# WAGGA WAGGA THEATRE SCHOOL OF ARTS

## Report on NCC Vol 1 BCA Compliance

**Eric Martin and Associates**

**ISSUE 1**

Figure 1: Marked up plan showing access issues

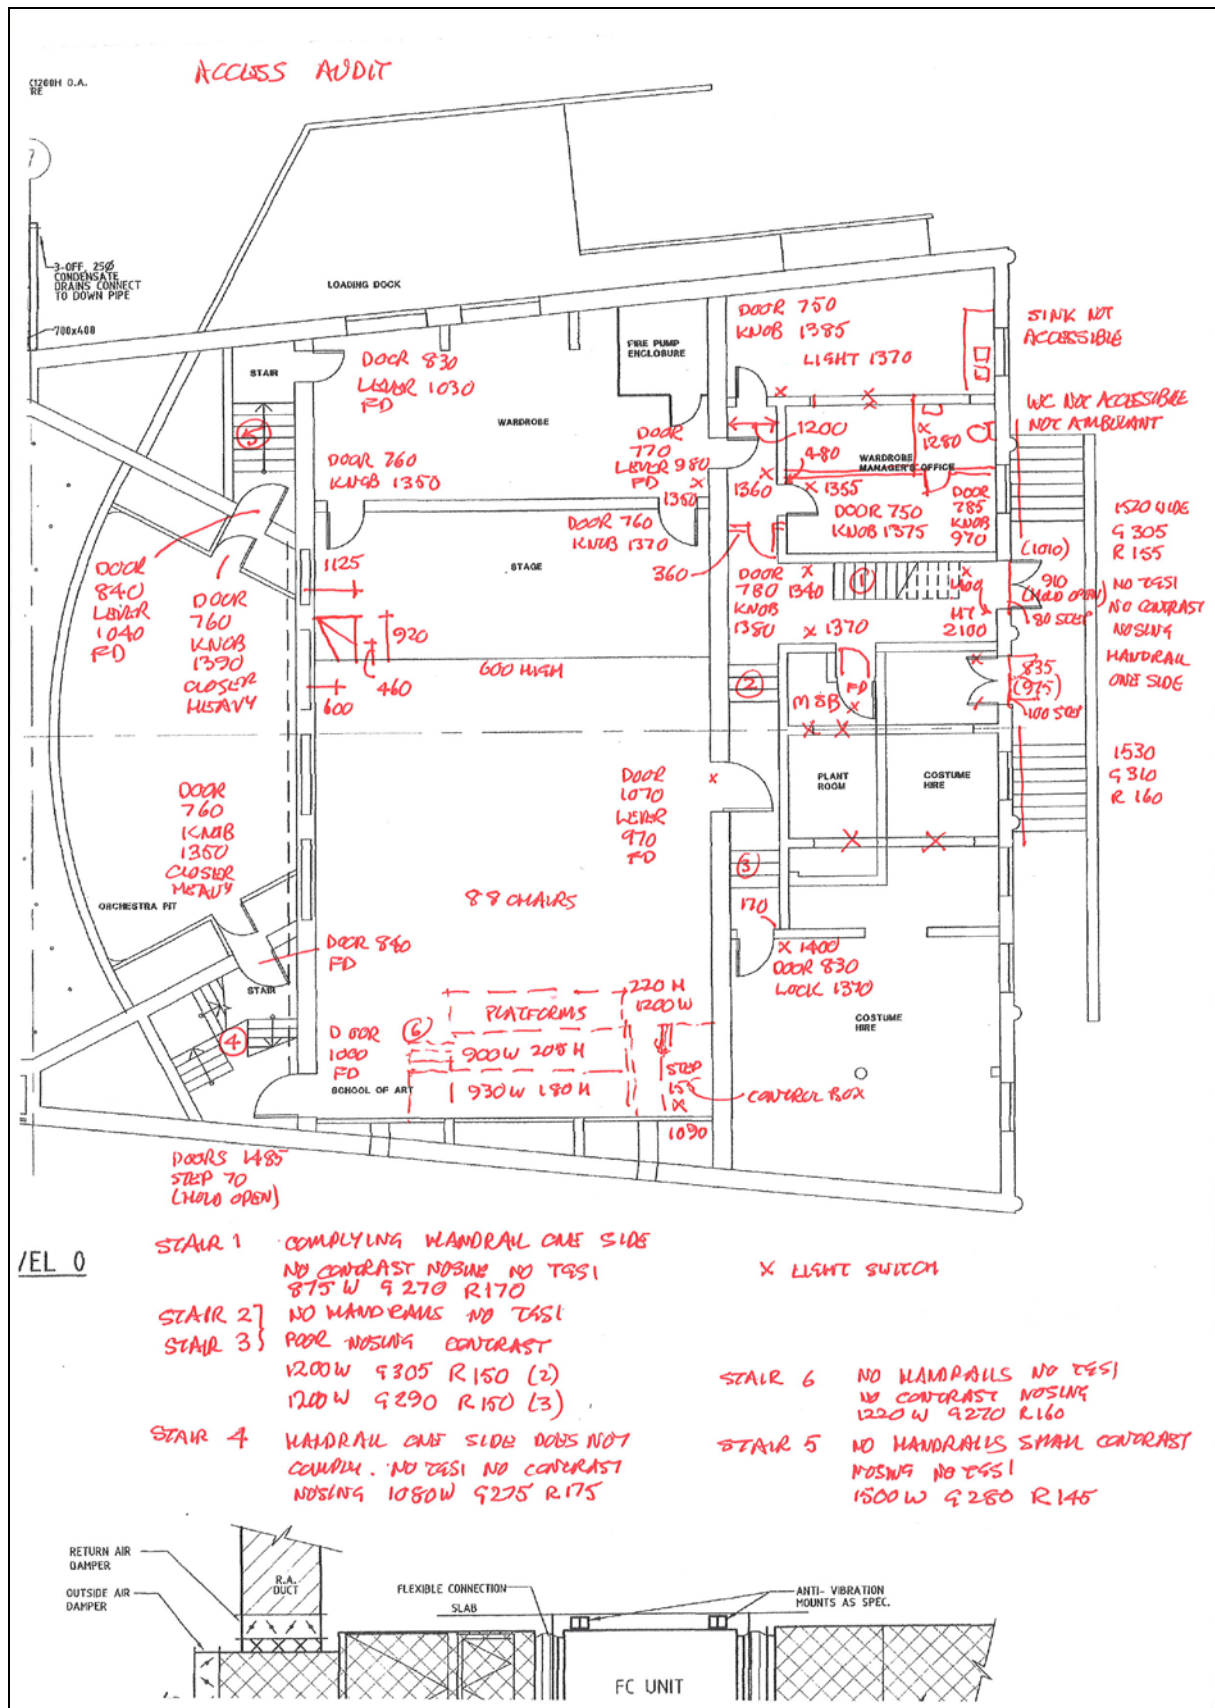
The main public access is from the side where the double doors are held open providing a clear opening of 1485mm but including a step of 70mm.

The administration entry is at the rear from stairs that do not comply with only one handrail (although stairs in both directions compensate for this), no contrast nosing and TGSi. The double doors can be held open providing a clear opening of 910mm but with a 80mm step. The low height (below 2000mm) at the admin entry does not include TGSi or a suitable barrier.

There is no lift to the theatre level from the public access. The stairs do not comply with a handrail one side, incorrect handrail, no contrast nosing and no TGSi.

There are internal stairs to restrict access from the back of theatre areas to the theatre. These stairs do not comply with no hand rails, no TGSi and poor contrast nosing.

All doors do not comply with most being too narrow, having inadequate circulation and many have knob handles and hardware that is too high.

There is one toilet which is neither accessible nor an ambulant facility and signage is non-compliant.

All light switches and security switch are too high.

- Rectify breaches of fire rating walls.
- Add handrails each side to AS1428.1 and contrast nosing to all stairs but maintain 1000mm clear width in main entry stair.
- Widen or relocate the admin entry to provide a minimum 1000m clear passage past the stair.
- Seating to be linked.

- Remove steps at entrances.
- A lift to the theatre level.
- A lift or ramp to the rest of floor level.
- An accessible toilet and signage.
- New doors and layout to meet circulation requirements.
- Replace exit signs including tactile/braille signs.
- Add TGSi to the general use stairs.
- Provide foyer.

### Figure 2: Annotated Plan

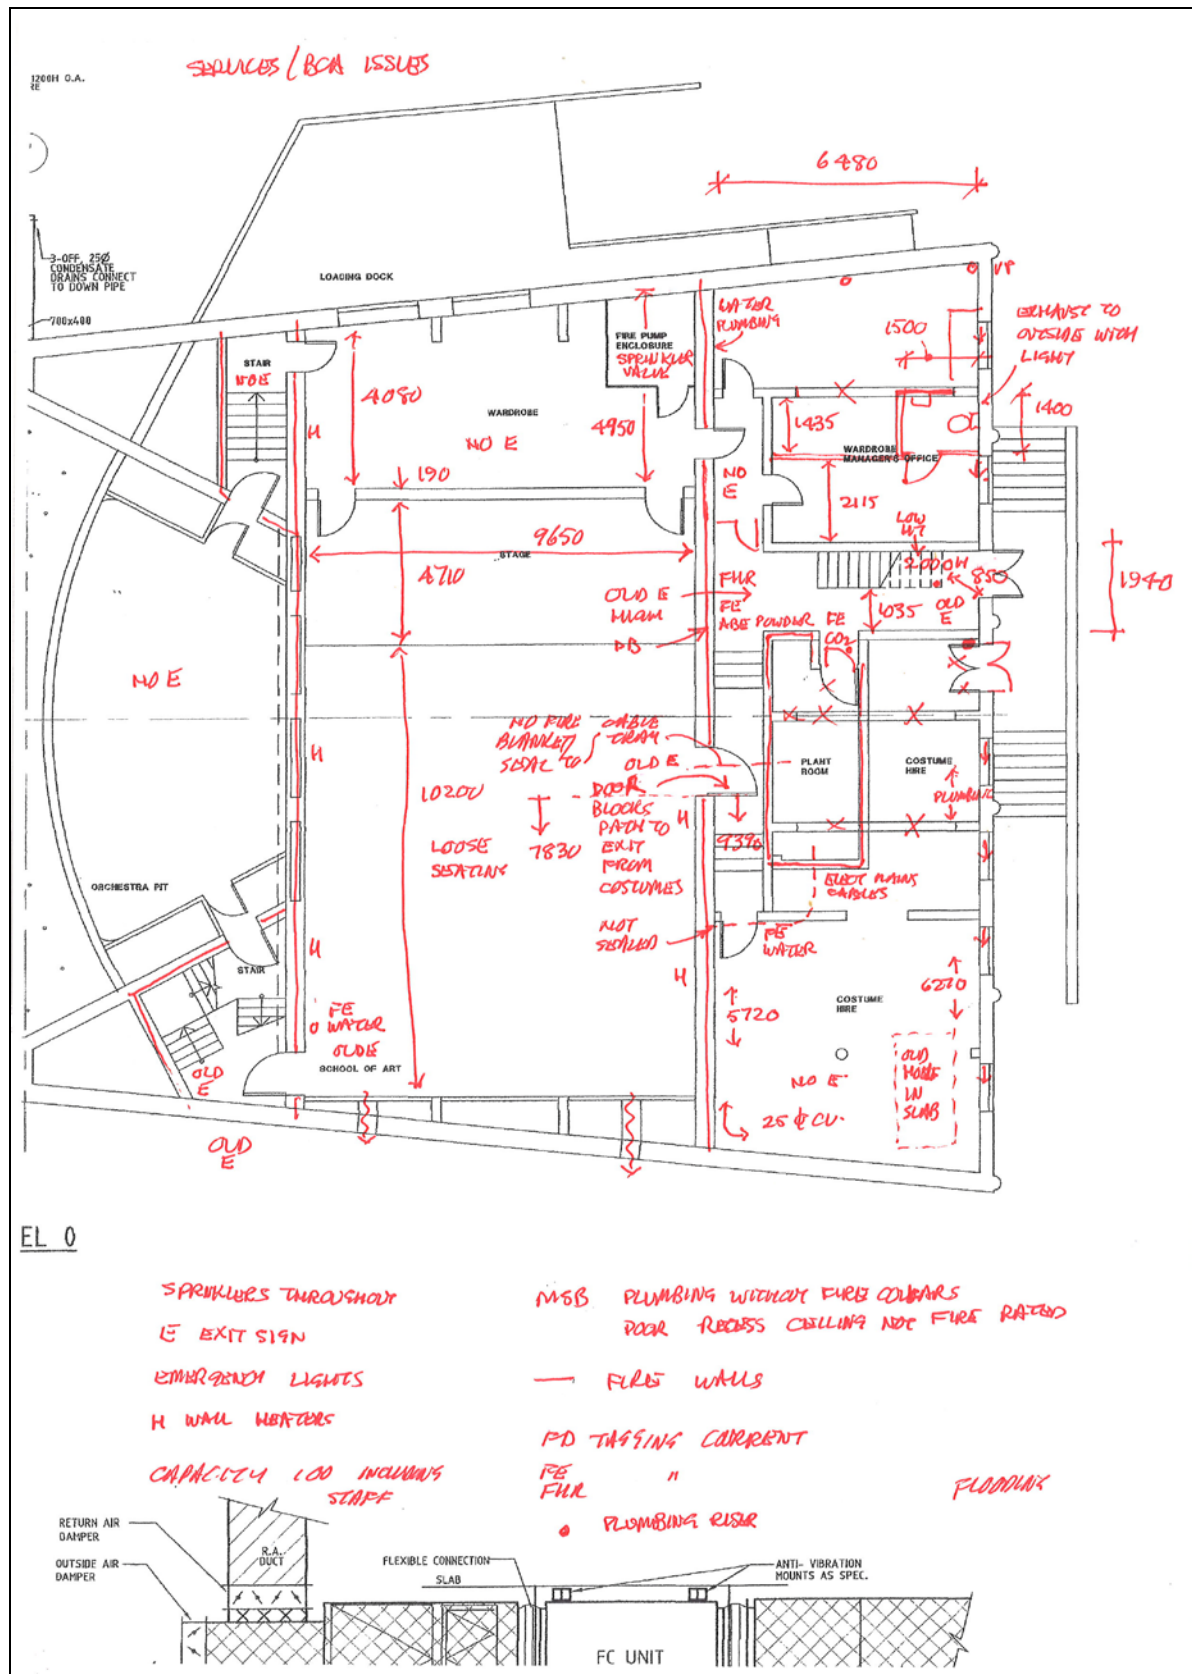
Risers/goings of all stairs comply but the balustrade at the main entry has openings in excess of 125mm diameter.

These exist but are the old type (not the running man) and do not provide coverage to office corridor and back stage.

The exit path to the main public entry complies but the exit to the admin entry is not wide enough as it crosses under the stairs (850mm wide).

There are fire rated sections and the facility is fire separated from the main theatre. The other area that is fire separated is the MSB. Fire doors are provided and tagged but there are penetrations through walls by electrical cables and a pumping pipe. The ceiling of the entry door recess to the MSB is not fire rated.

The whole area is sprinklered and includes a FHR (although more than 4m from an exit door) and fire extinguishers are strategically placed. All services are tagged and current and would appear to be sufficient. The fire sprinkler valve enclosure is within the back stage area which is unusual.

There are two vents in the rear wall of the theatre and four wall-mounted electrical heaters. NCC 2015 Vol 1 BCA requires ventilation or air conditioning to AS1668.2 and AS3666.1.

The ventilation would appear inadequate.

This appears adequate except no aisle lights are provided.

There is effectively no foyer. NCC 2015 Vol 1 BCA clause NSW H101.3 requires a foyer space of 0.25m<sup>2</sup> per person or 25m<sup>2</sup>.

3.9.1 The theatre seats are not linked together and pose a risk in an emergency.

3.9.2 The stair to the upper level (back stage of main theatre) does not meet requirements for a general access stair but serves no purpose for the School of Arts function and little purpose for the main theatre

Figure 3: Possible Layout A

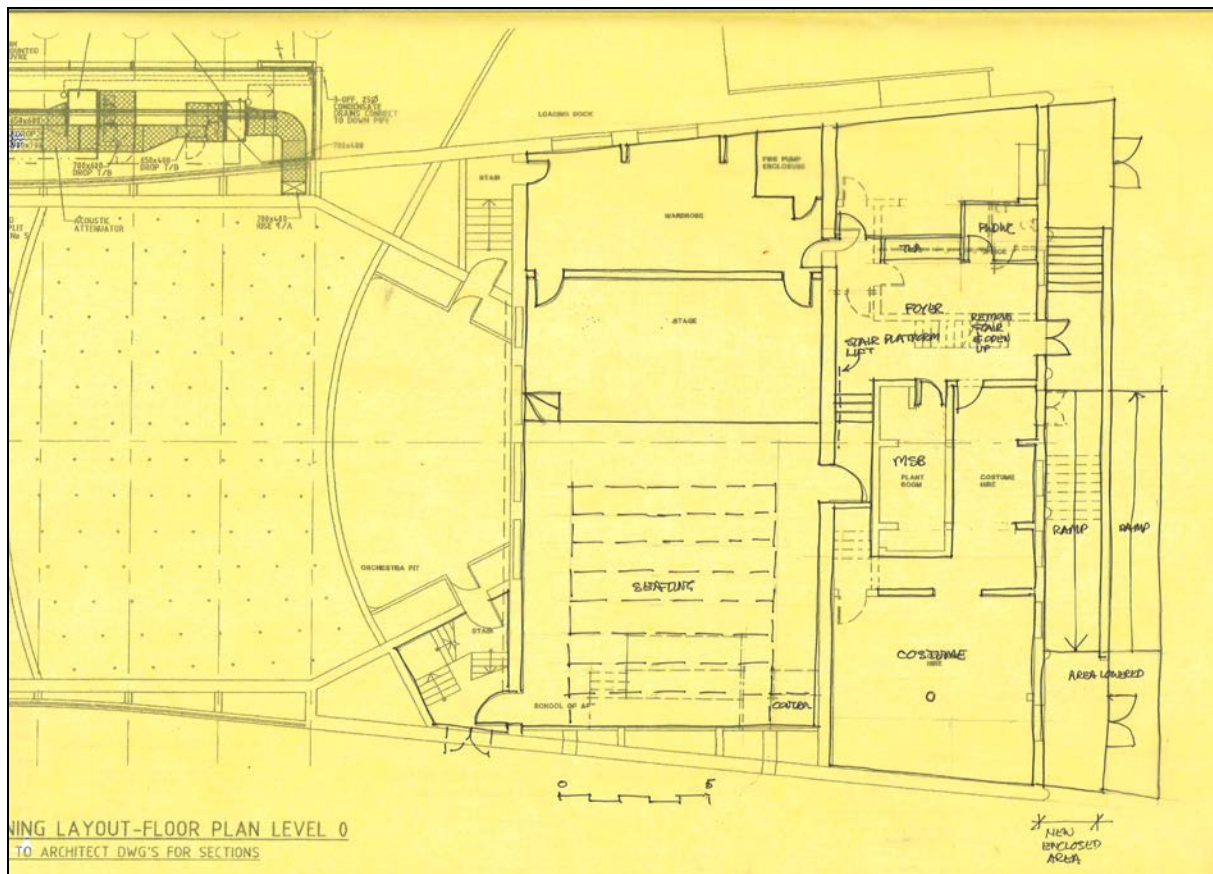
A possible layout that would satisfy the above requirements is indicated in Figure 3 and Figure 4.
